MECKLENBURG COUNTY
DEPARTMENT OF ENVIRONMENTAL HEALTH

APPLICATION FOR SOIL INVESTIGATION

APPENDIX II
SITE EVALUATION

SITE INVESTIGATION REPORT
INDIVIDUAL SEPTIC TANK SYSTEM
WITH SUBSURFACE,
SOIL ABSORPTION,
EFFLUENT DISCHARGE

* See Diagram on Back (Include: Soil areas, property lines, roads, streams, gullies wet areas, fill areas, wells, water bodies, slope patterns, etc

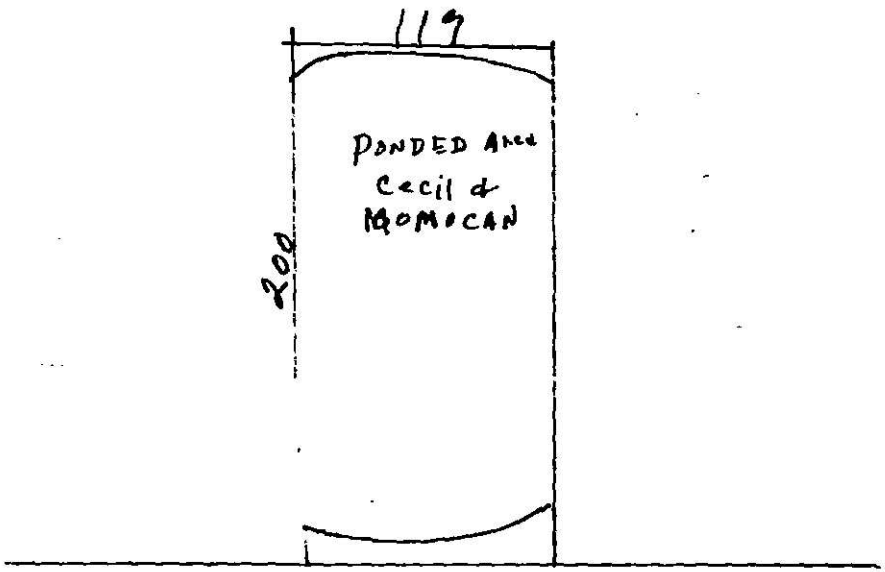
Recommendations/Comments: MAIN Problem SEEM To Be Caused By Water Being Dammed By Rd

119
PONDED AREA
Cecil & MOMOCAN
200
